**ZONING CHANGE REVIEW SHEET****CASE:** C814-2017-0001 – 425 W. Riverside PUD**Planning Commission Date:** February 13, 2018  
February 27, 2018**ADDRESS:** 425 W. Riverside Drive**OWNER/APPLICANT:** Ronald A. Nelson and Molly Belle Properties (Ronald Nelson, Trustee)**AGENT:** Armbrust & Brown (Richard Suttle)/Stream Realty (David Blackbird)**ZONING FROM:** CS-1-V-NP      **TO:** PUD-NP**AREA:** 1.45 acres (63,162 sq. ft.)**SUMMARY STAFF RECOMMENDATION:**

- This report includes all comments received to date concerning your proposed planned unit development. The PUD will be scheduled for Commission when all requirements identified in this report have been addressed.
- PLEASE NOTE: IF YOU HAVE ANY QUESTIONS, PROBLEMS, CONCERNS OR IF YOU REQUIRE ADDITIONAL INFORMATION ABOUT THIS REPORT, PLEASE DO NOT HESITATE TO CONTACT YOUR CASE MANAGER (referenced above) at the CITY OF AUSTIN, PLANNING AND ZONING DEPARTMENT, P.O. BOX 1088, AUSTIN, TX.

EXHIBIT F - LAND USE PLAN-OPEN SPACE

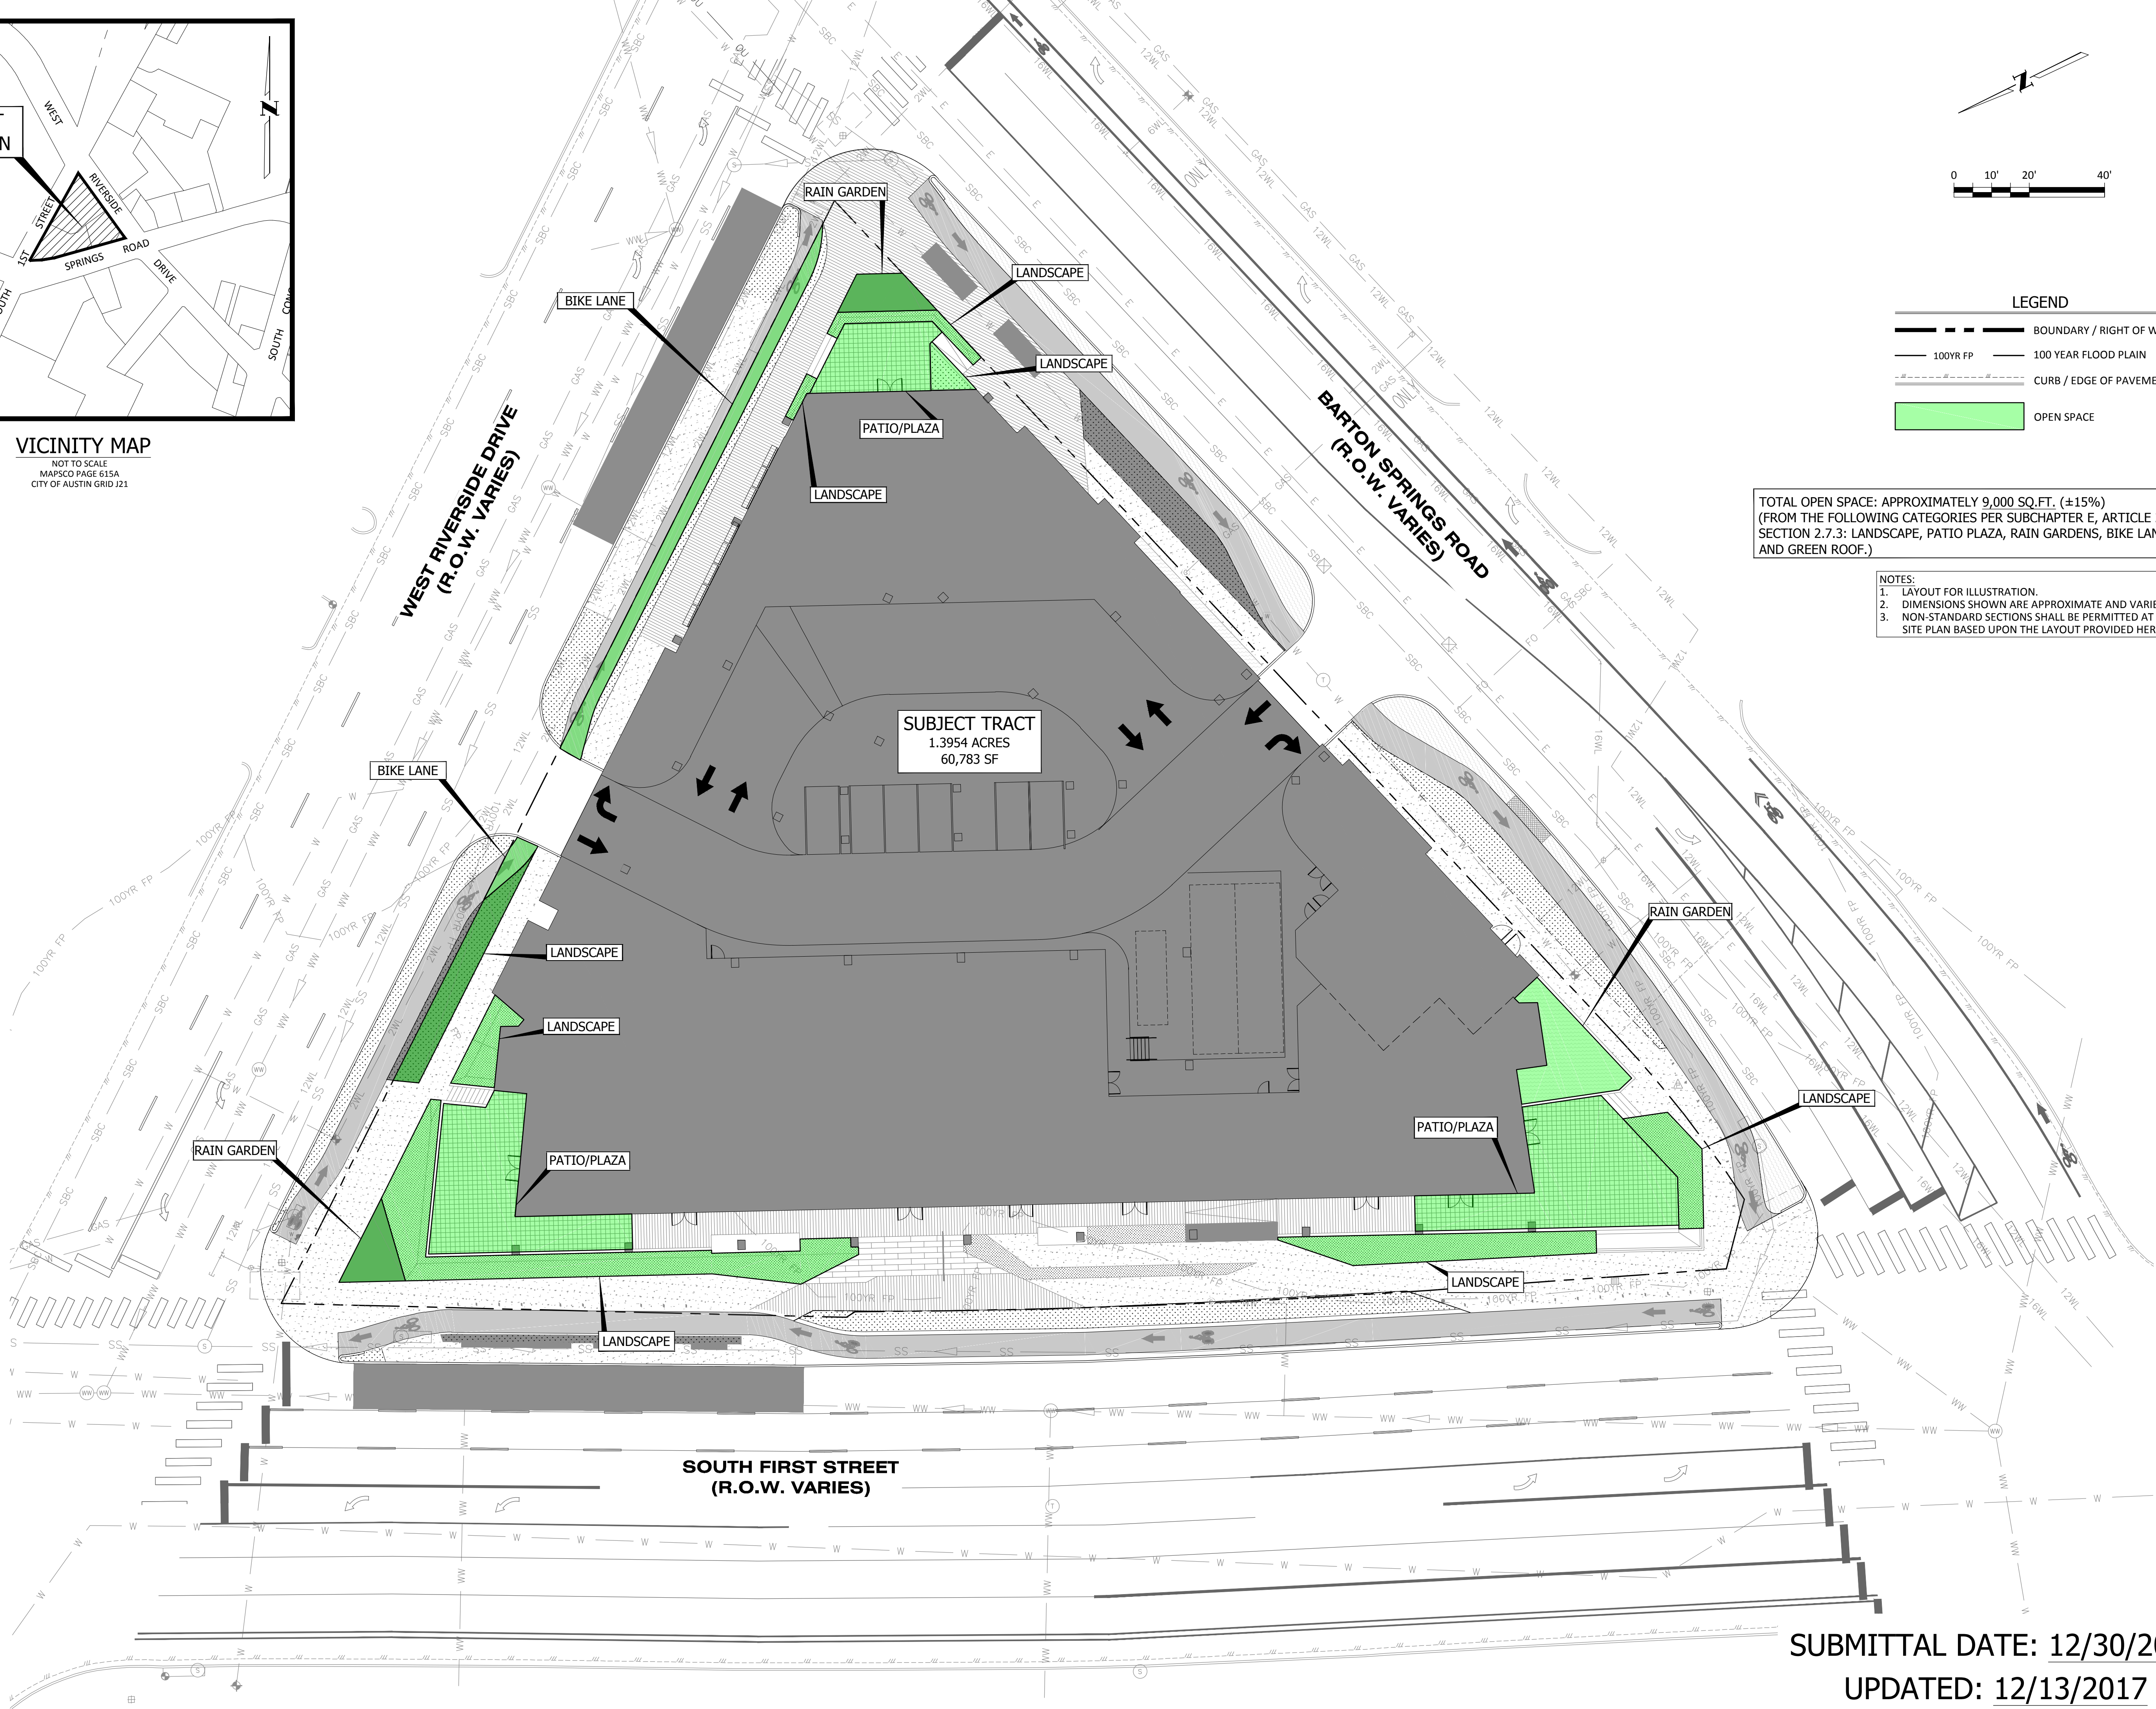
**U3: The proposed Open Spaces A, B, C, and D (green roof) are acceptable, as is the minimum commitment of 15% of the site. However, please prepare an open space exhibit that can be included with the PUD ordinance. (Something like the submitted exhibit can be used, but it currently says “for informational purposes only – Update 2”). This comment can be cleared informally.**
